Addendum No. 1

Project: Quote to Provide Mast Arms/Poles & Related Hardware
Intersection of SR 44/Lake Oconee Parkway & Scott Road

Bid Item #: 21-42001-003

DEPARTMENT OF TRANSPORTATION STATE OF GEORGIA	
CONSTRUCTION DETAIL	
STRAIN POLE AND MAST ARM FOUNDATIONS	
NOVEMBER 2020 NO SCALE	NUMBER TS-05

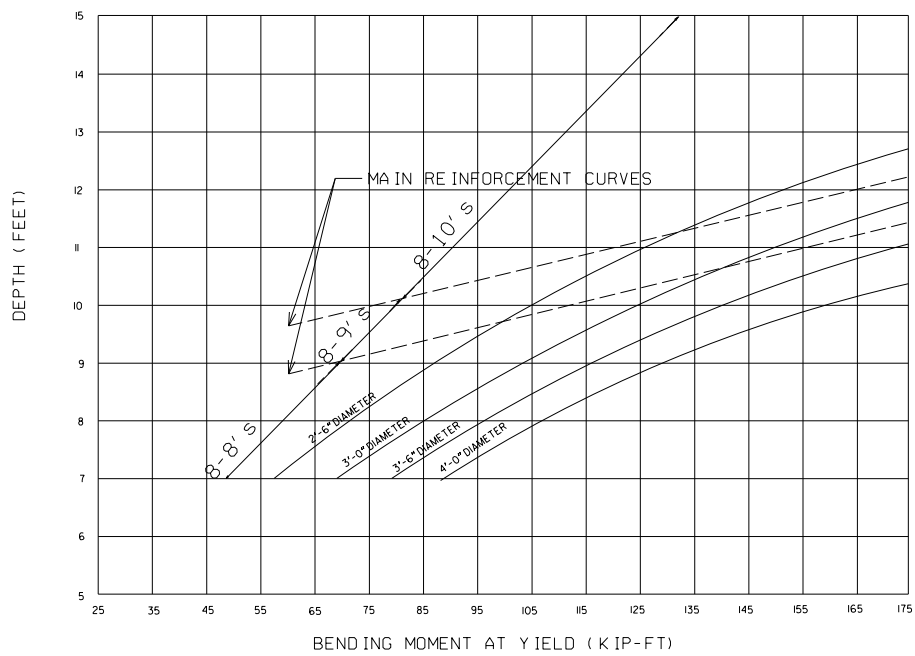
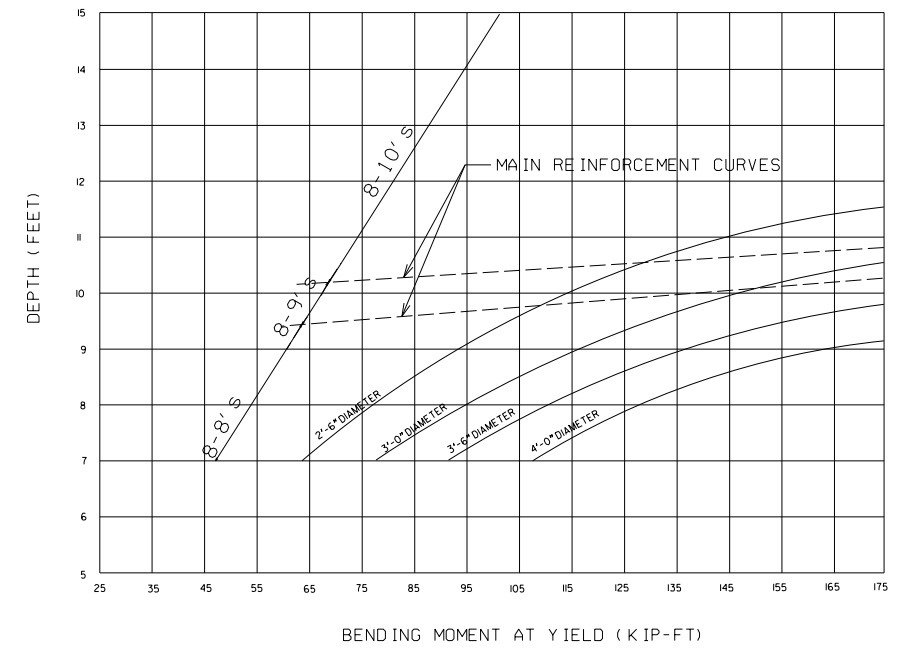
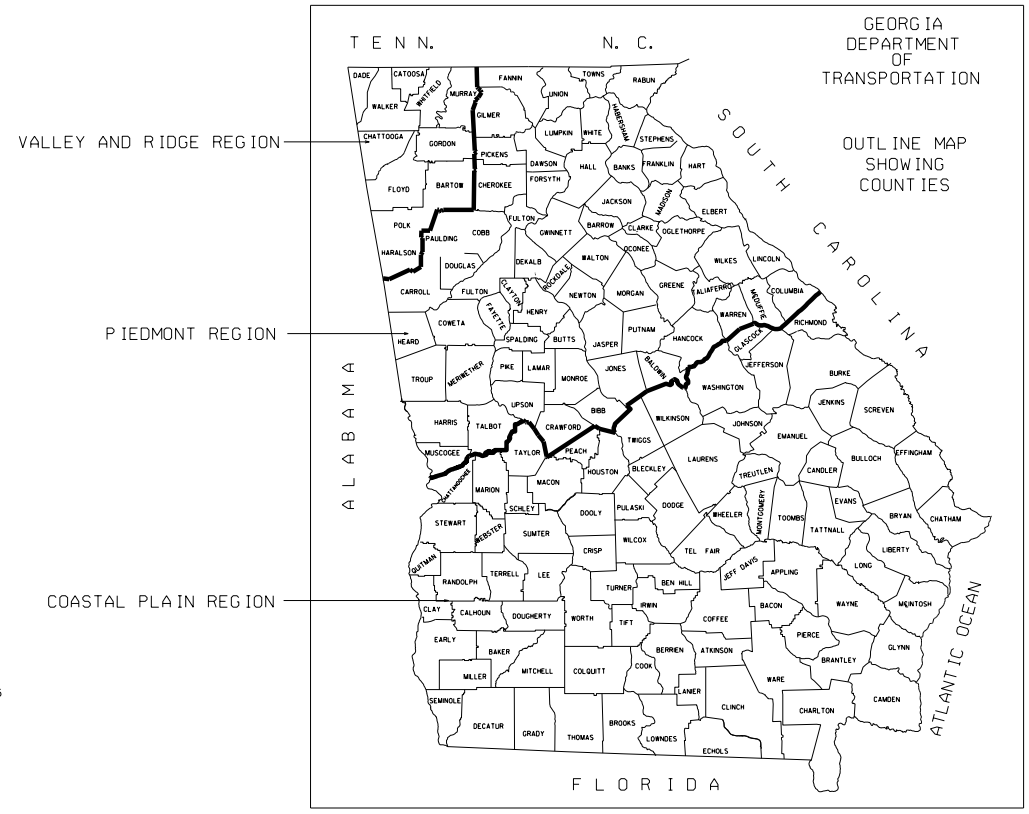
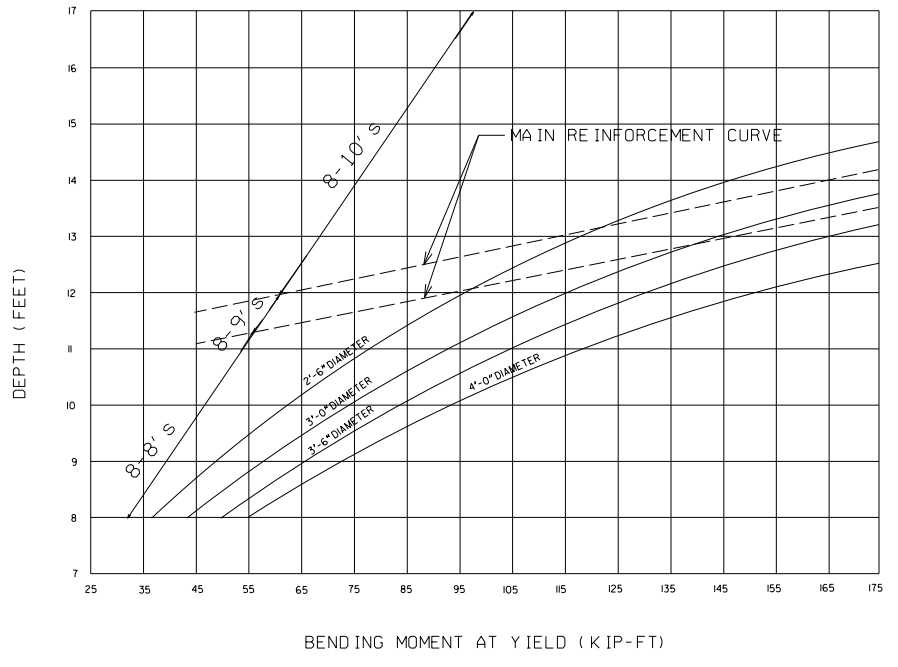
Beginning on 4/16/2021, the following GDOT 2021 Specification for **Strain Pole and Mast Arm Foundations**, which was adopted by GDOT on March 19th, 2021, shall be applicable to all projects on state right-of-way. This new specification shall replace the details on the "Request for Quote" dated April 26th, 2021.
